Site Specific
TRAFFIC CONTROL PLAN
For FAIRFIELD BRO 1448(41)

Fairfield BCP TCP Revise 12-24-2014.pdf

ROUTE NO : ELM BROOK ROAD, TOWN HIGHWAY 47 (CLASS 3) TOWN BRIDGE NO : 46

PROJECT DESCRIPTION: REPLACEMENT OF EXISTING BRIDGE WITH RELATED ROADWAY APPROACH AND CHANNEL WORK.

TRAFFIC LAYOUT SHEET

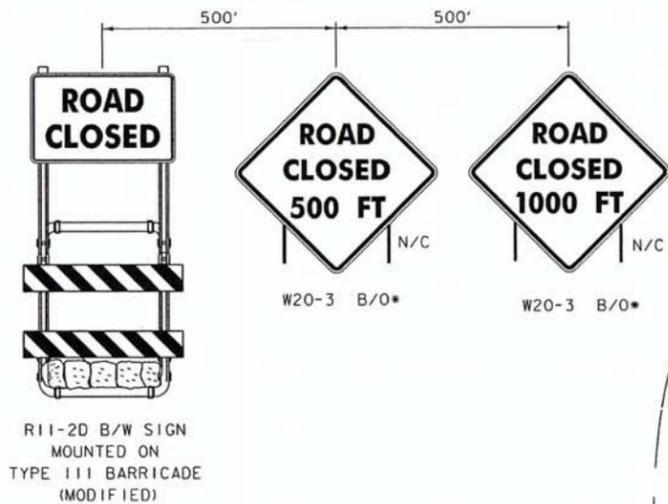
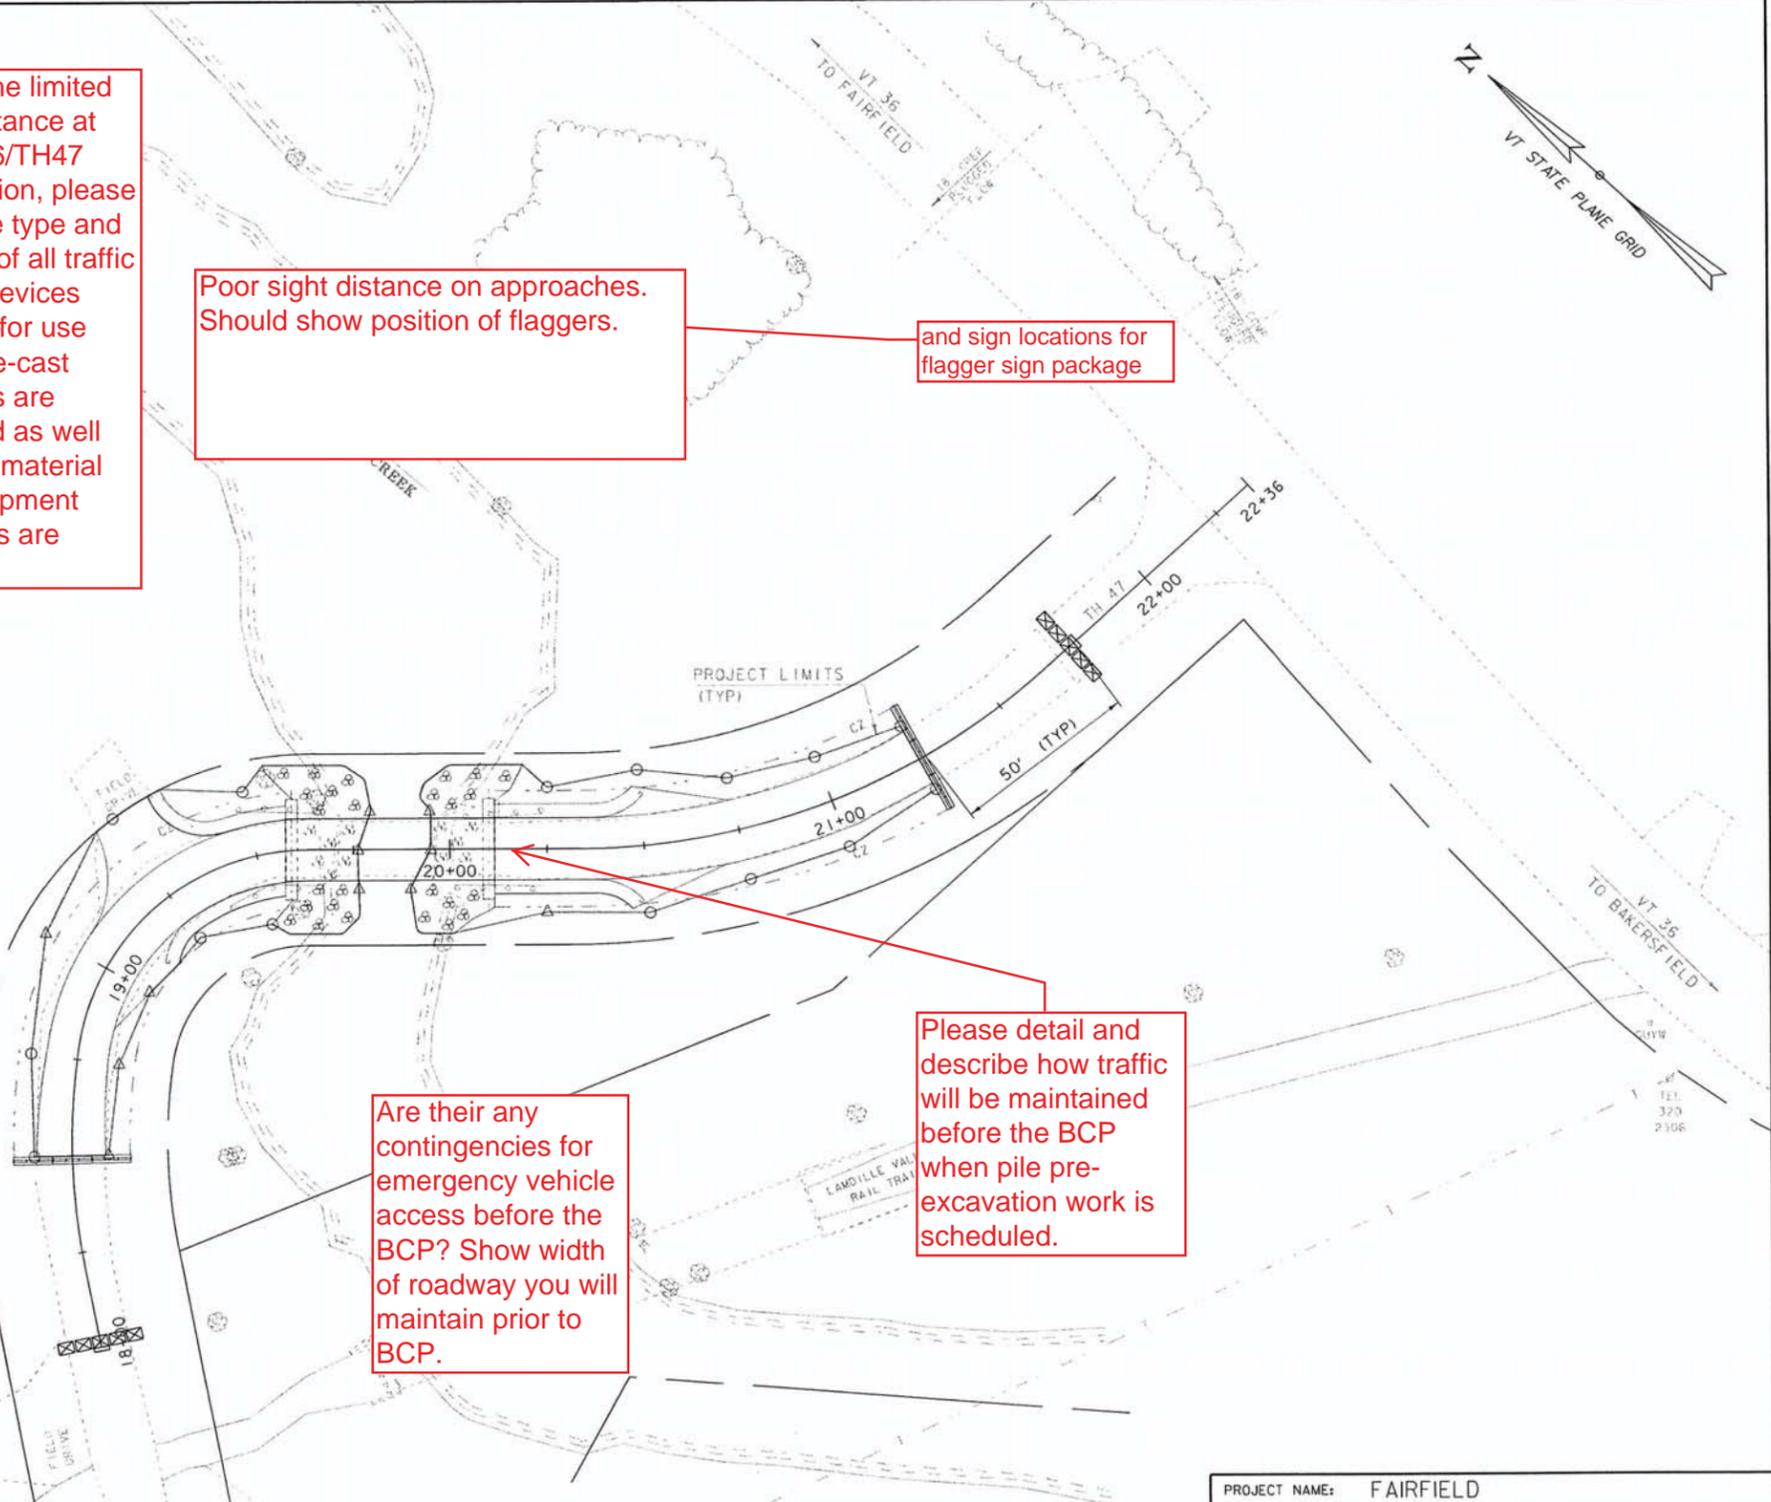
Due to the limited sight distance at the VT36/TH47 intersection, please show the type and location of all traffic control devices planned for use when pre-cast elements are delivered as well as other material and equipment deliveries are made.

Poor sight distance on approaches. Should show position of flaggers.

and sign locations for flagger sign package

Please detail and describe how traffic will be maintained before the BCP when pile pre-excitation work is scheduled.

Are there any contingencies for emergency vehicle access before the BCP? Show width of roadway you will maintain prior to BCP.

Where is the lighting for access through the workzone at night and during the BCP?

**CONVENTIONAL ROADS
CONSTRUCTION APPROACH
SIGNING**

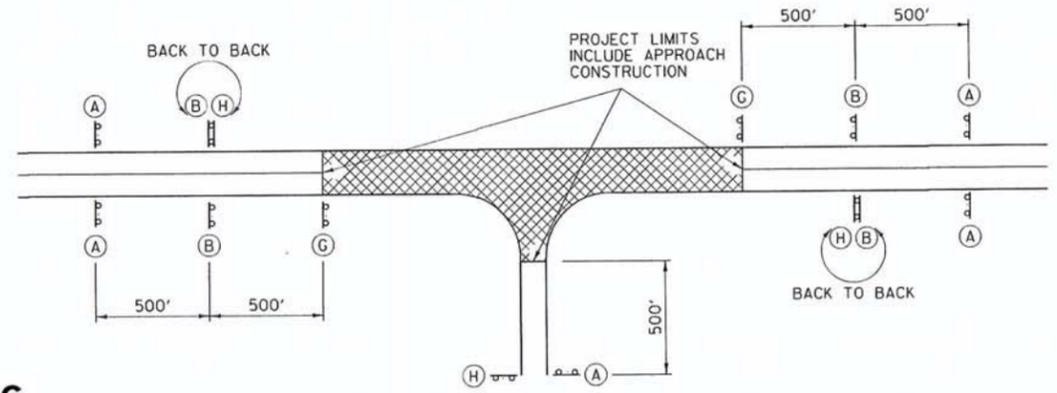
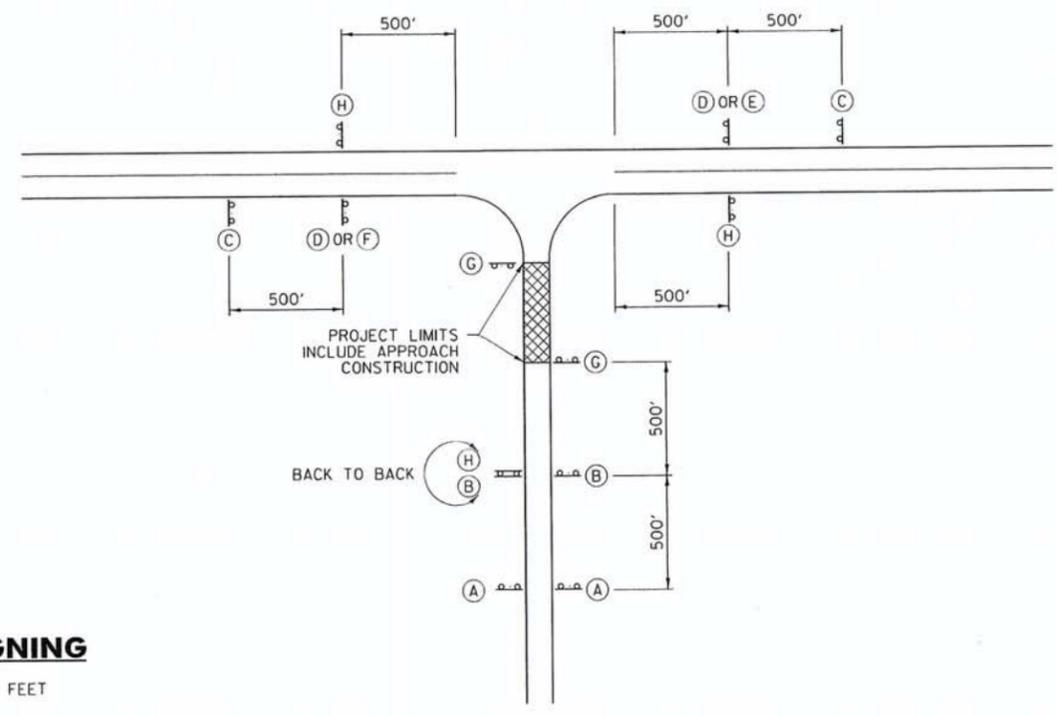
Identify what is being used on this sheet, add road names for clarity.

TCP5

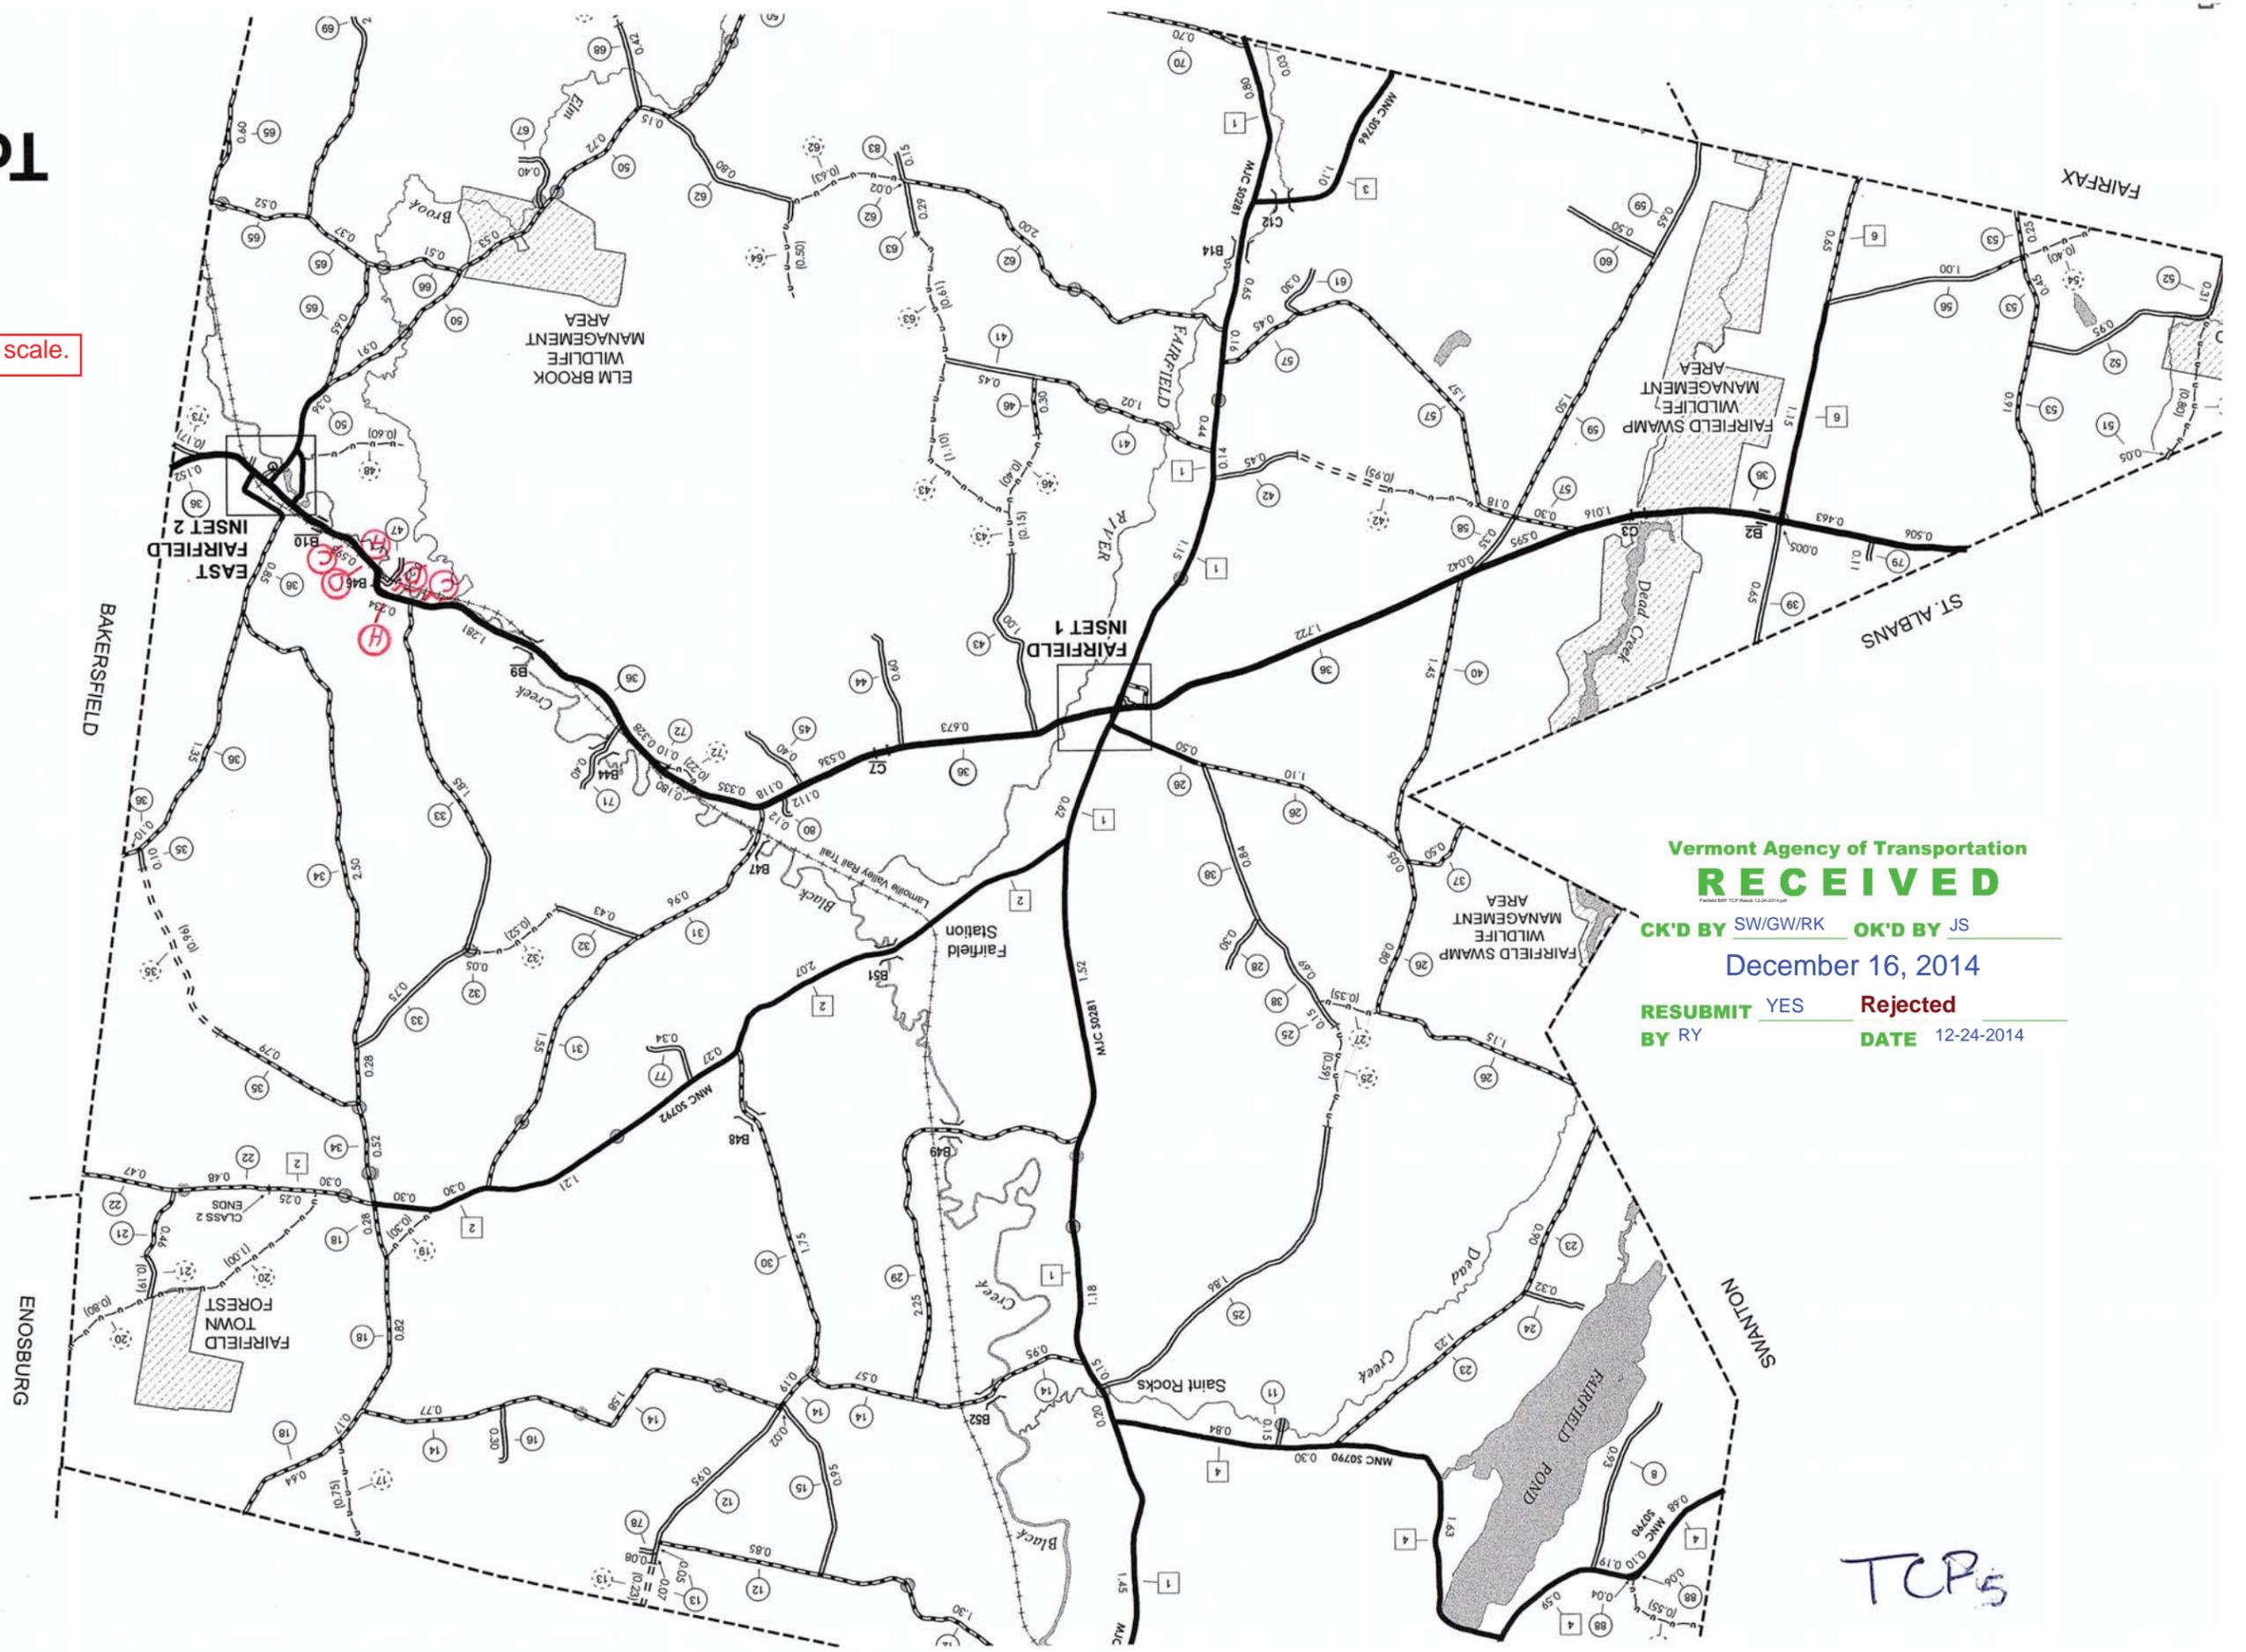
Not legible at this scale.
